CITY OF SOUTHGATE PLANNING COMMISSION AGENDA

1. Site Plan review for proposed hotel establishment, 12500 Reeck Road

September 18, 2024

Site Plan Review

DRAWN BY: **ALC**
 CHECKED BY: **ALC**
 DATE: **1-1-88**
 JOB NO: **FD-27-204**
 SHEET TITLE: **WHITE LAYOUT AND
PAVING PLAN**
 SHEET: **04-2227**
C3.0

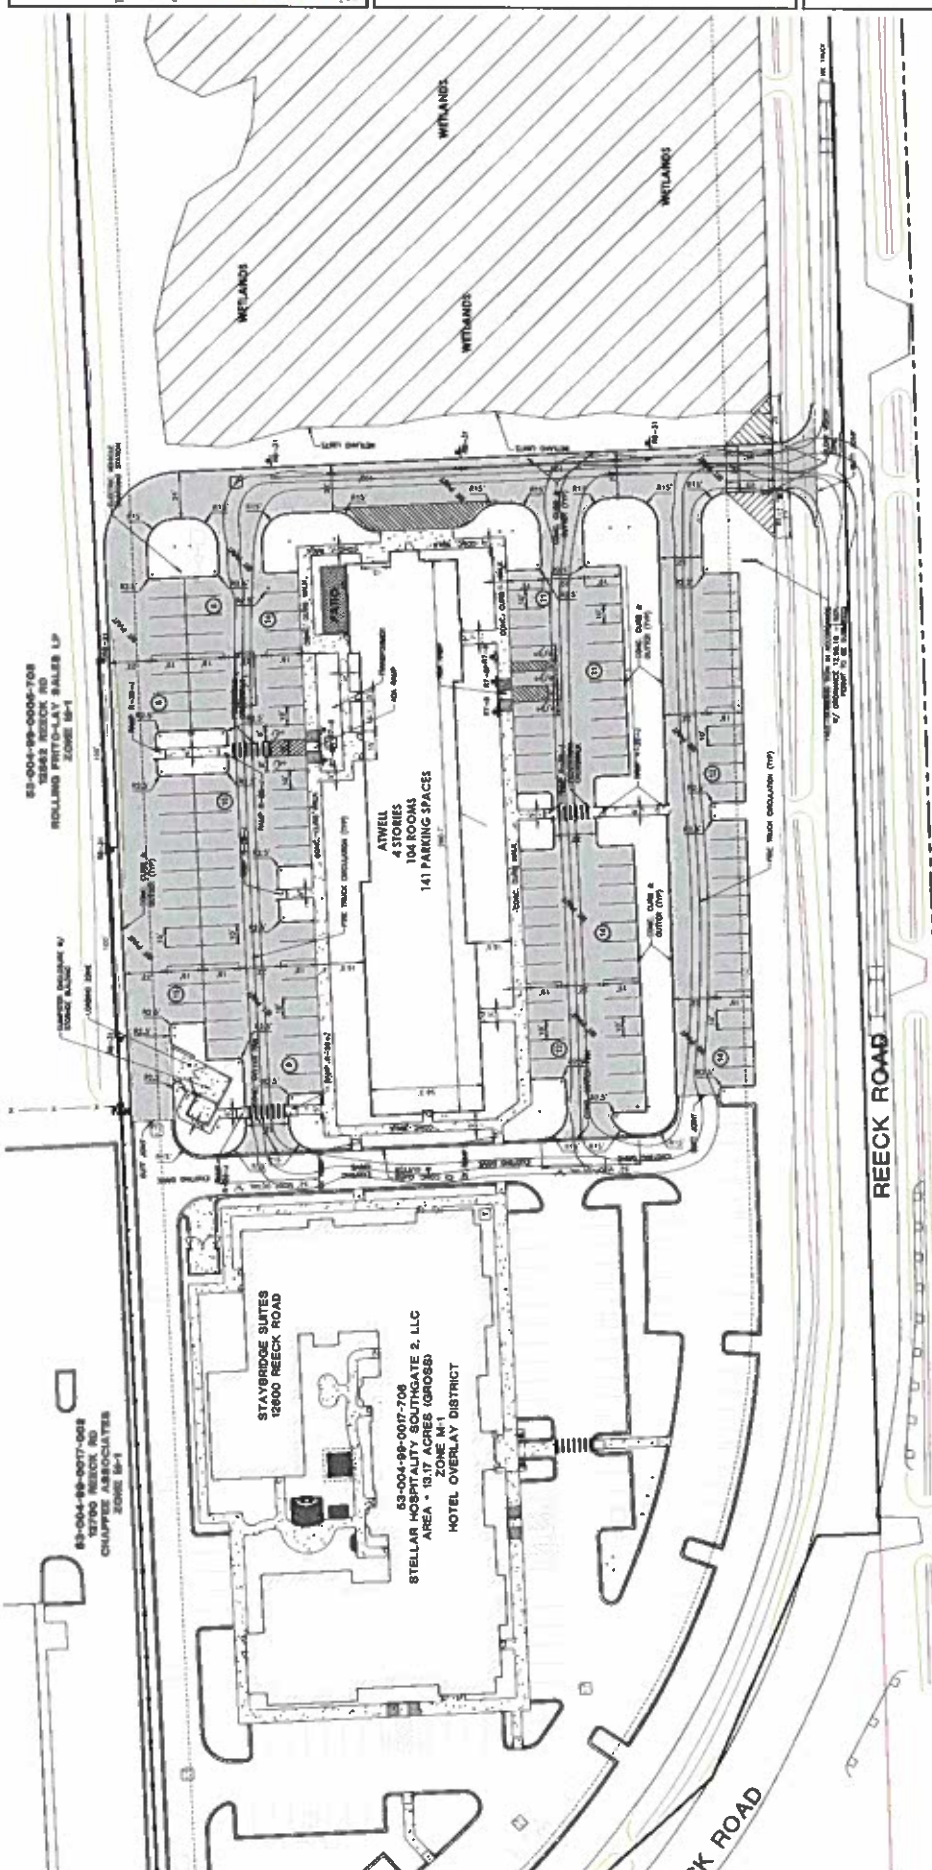
Loading areas within industrial districts are required based on gross floor area of the principal building, which has not been provided. The applicant has indicated that minimal deliveries are anticipated. We ask for further clarification, as there seems to be a parking area on the east side of the building which could serve as adequate loading space.

Waste/Dumpster Enclosure: A dumpster enclosure eight (8) feet in height is proposed on the southeast corner of the site. A storage building is also proposed next to the enclosure, for which we ask the applicant to provide greater clarification.

CWA Comment: *We ask the applicant to provide a measurement from the Reeck Road right of way line to the edge of the east parking area to confirm the requirement has been met.*

Sheet Title:
**EXTERIOR
ELEVATIONS**

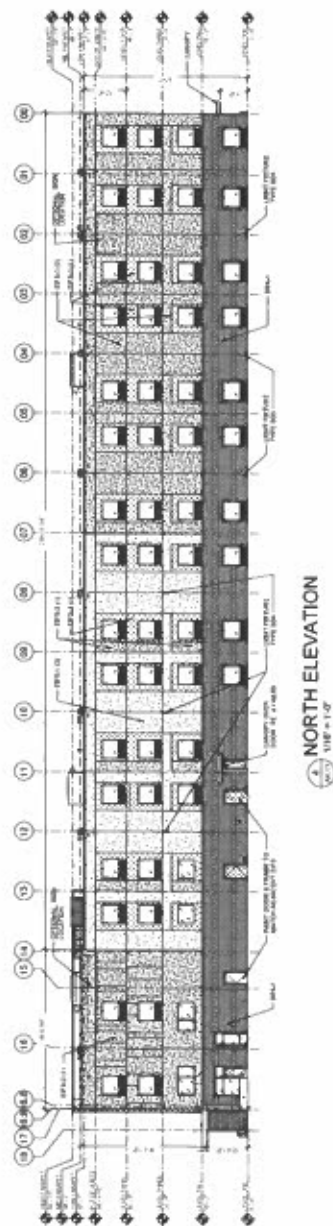
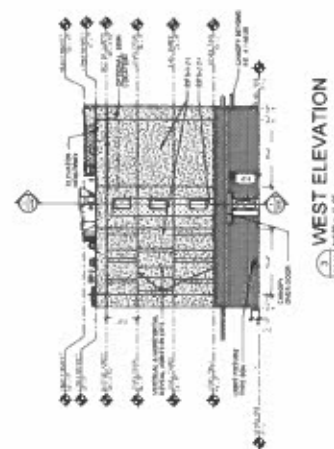
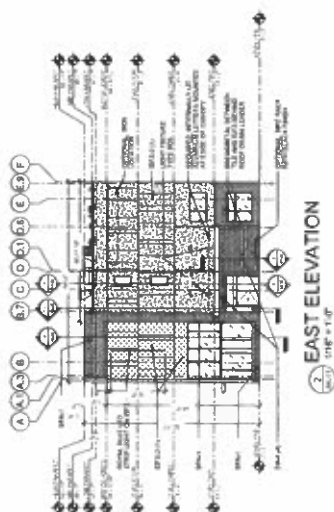
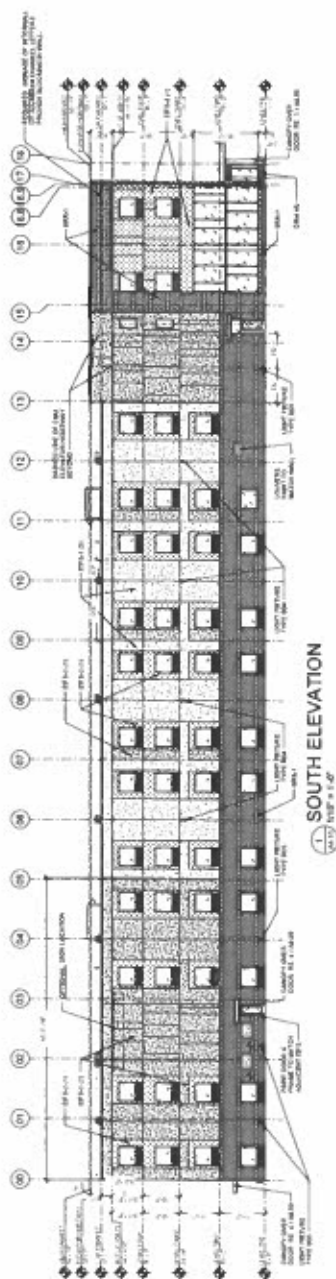
Current Building elevations show a building height of fifty (50) feet. A variance through the City Board of Zoning Appeals will be required to maintain the proposed height.

Items to be Addressed: Reduce building height to forty (40) feet or Seek variance for proposed height through the Board of Zoning Appeals

Building elevations on sheet A4.10 show building mounted lighting, however, there does not appear to be fixture specifications provided. We ask the applicant to provide these specifications to ensure all lighting remains down shielded.

CWA Comment: *The current height of the building is set at fifty (50) feet. The height will need to be corrected to the 40-foot requirement, or a variance through the Board of Zoning Appeals will be required.*
